SUBMISSION

a written submission by way of objection

16 July 2024

LAND & ENVIRONMENT COURT PROCEEDINGS NO. 2023/00242901
PROPERTY: 1102 BARRENJOEY ROAD, PALM BEACH
DA NUMBER: NBC DA2022/0469
APPLICANT: ASIA DIGITAL INVESTMENTS PTY LTD
RESPONDENT: NORTHERN BEACHES COUNCIL
PROPOSAL: DEMOLITION & CONSTRUCTION OF A SHOP TOP HOUSING AT 1102
BARRENJOEY ROAD, PALM BEACH

Sketch: The risks of positioning an Elevated Piling Mat, perhaps a separate steel structure, that is >10m high, to support a >40-ton Piling Rig >30m high has not been assessed by the JK Report.

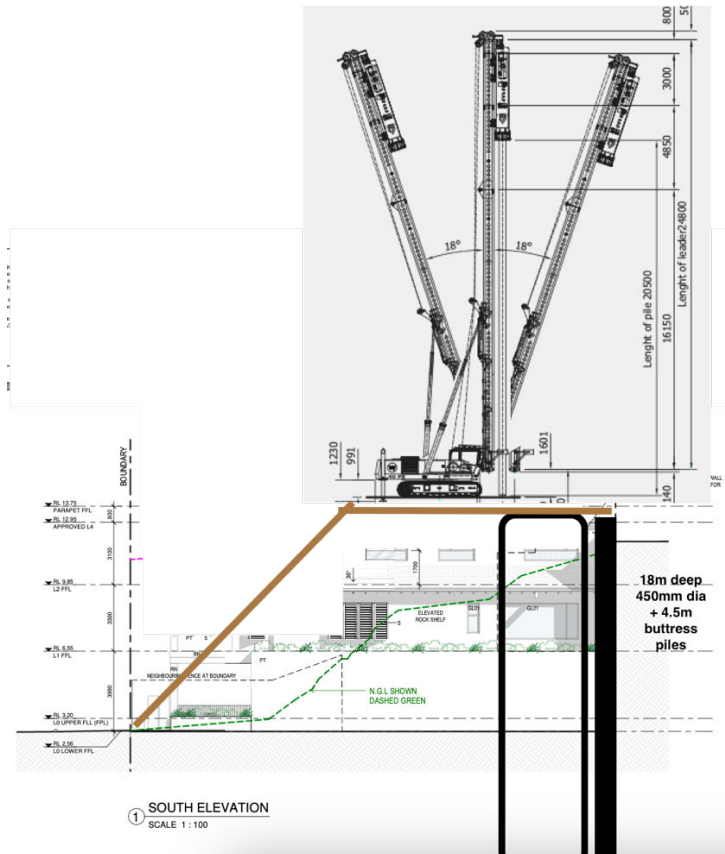
- The design of the temporary works that will be required to be built on the boundary, particularly to the east of the site, defined within the VDM drawings, where >18m deep piles will need to be positioned at an elevation >10m above the base of the existing slope. JK Report does not address this important matter.

- The Piling Mat will need to be positioned at a height at the top of the eastern piled wall, that is inaccessible from a normal sloped ramp approach for a Piling Rig, and appears to require an Elevated Piling Mat, perhaps a separate steel structure, that is >10m high, to support a >40-ton Piling Rig, and that Rig would be >30m high. The Piling Rig would be required to be craned into position. JK Report does not address this important matter.

- The Elevated Piling Mat would need to be built on the boundary of the heritage item, Barrenjoey House. JK Report does not address this important matter.

- It is uncertain how the Piling Mat would be piled in the zones to the east of the existing retaining wall on the subject site. JK Report does not address this important matter.
